CITY OF LOS ANGELES
INTER-DEPARTMENTAL CORRESPONDENCE

130 W College St
DOT Case No. CEN22-54014

Subject: **TRANSPORTATION ASSESSMENT FOR THE PROPOSED OFFICE AND COMMERCIAL PROJECT LOCATED AT 130 WEST COLLEGE STREET (CPC-2023-2306-GPA-VZC-HD-MCUP-SPR/ENV-2023-2307-EIR)**

PROJECT SITE PLAN

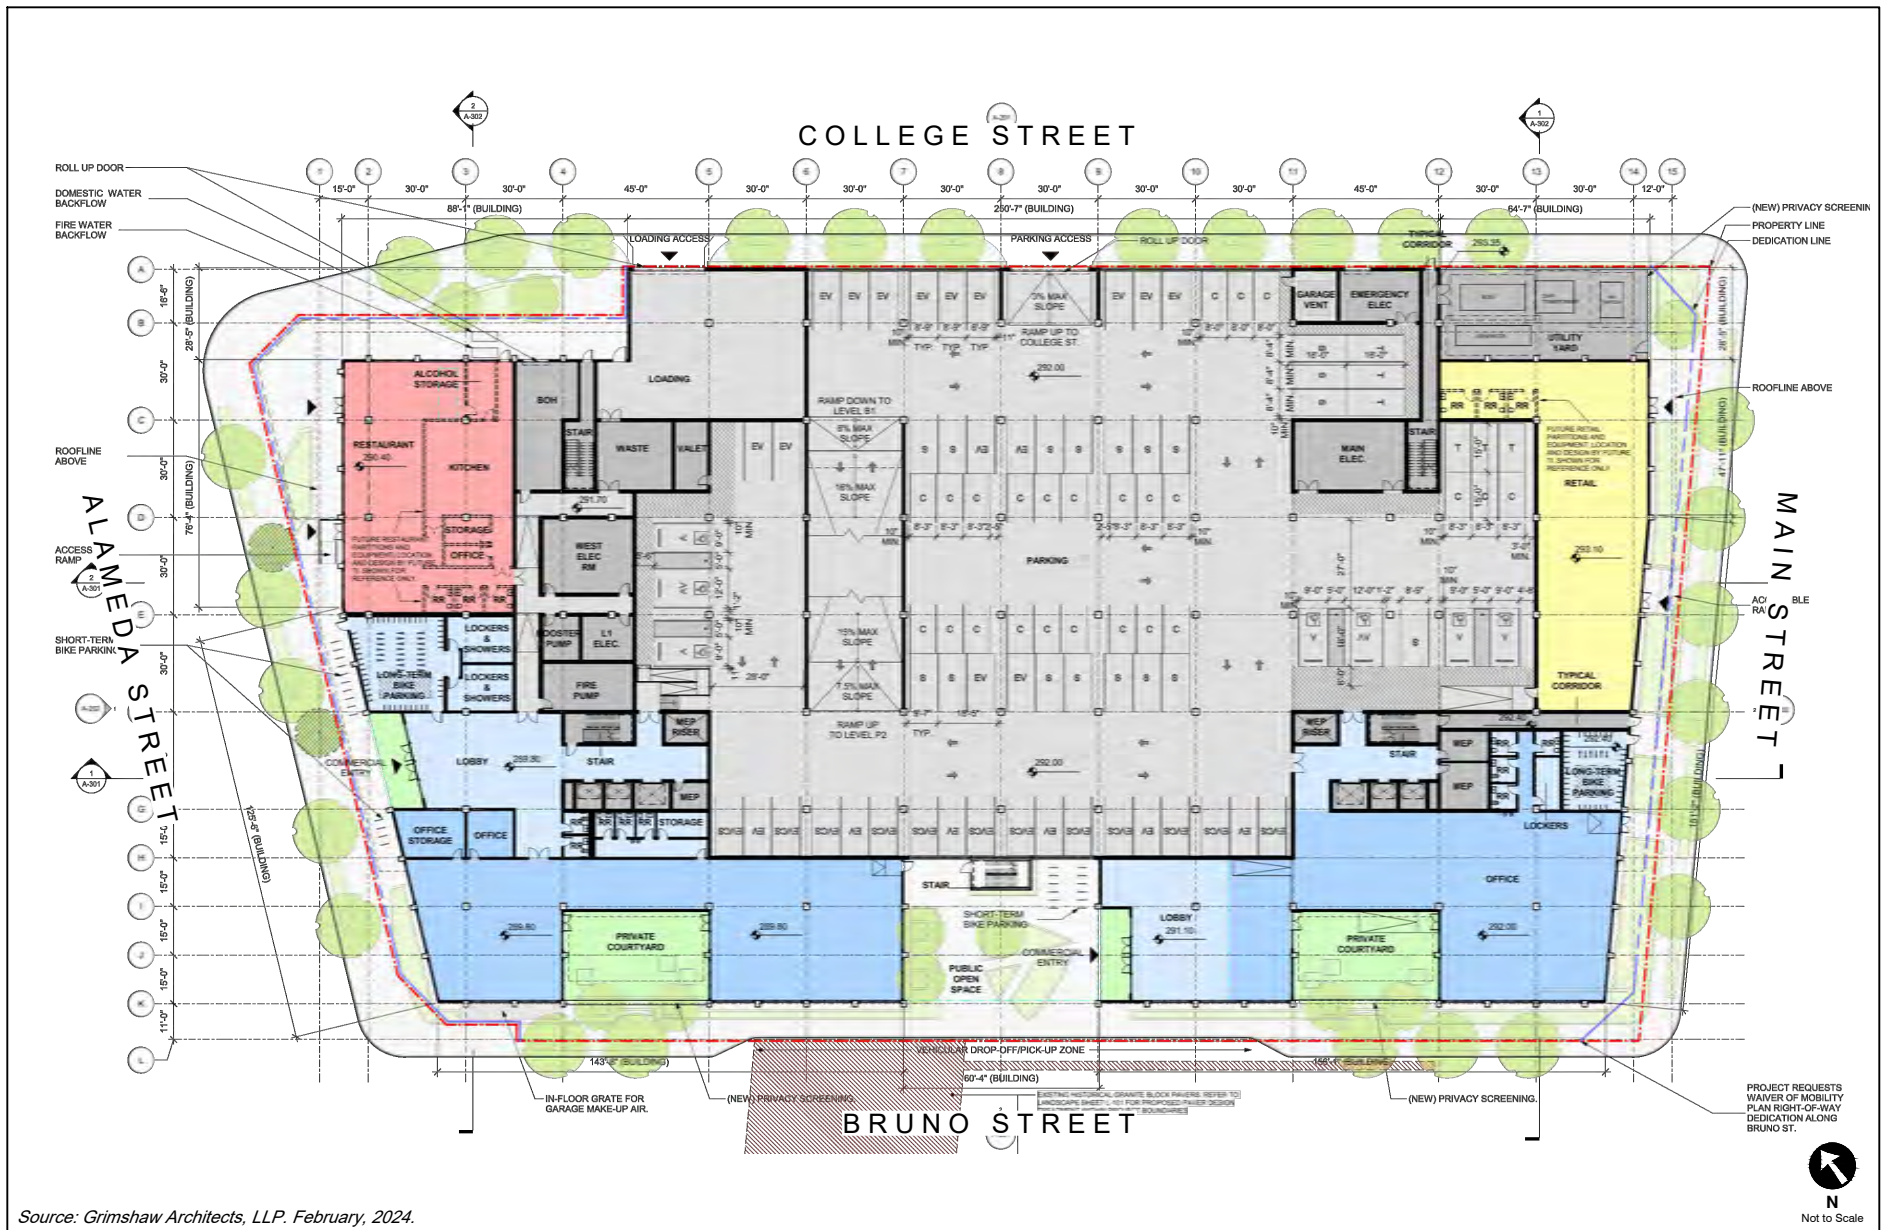
The conceptual site plan for the project (see **Attachment A**) is acceptable to LADOT. Vehicular access to the project would be provided along College Street via a full-access driveway to the parking garage and a separate driveway to the commercial loading area. Separate pedestrian and bicycle access would be provided along Main Street, Bruno Street, and Alameda Street. Passenger loading areas would be provided along Bruno Street and on-site in the parking garage. Review of this study does not constitute approval of the dimensions for any new proposed driveway. Review and approval of the driveway should be coordinated with LADOT's Citywide Planning Coordination Section <ladot.onestop@lacity.org>. In order to minimize and prevent last minute building design changes, the applicant should contact LADOT for driveway width and internal circulation requirements prior to the commencement of building or parking layout design. The applicant should check with City Planning regarding the project's driveway placement and design.
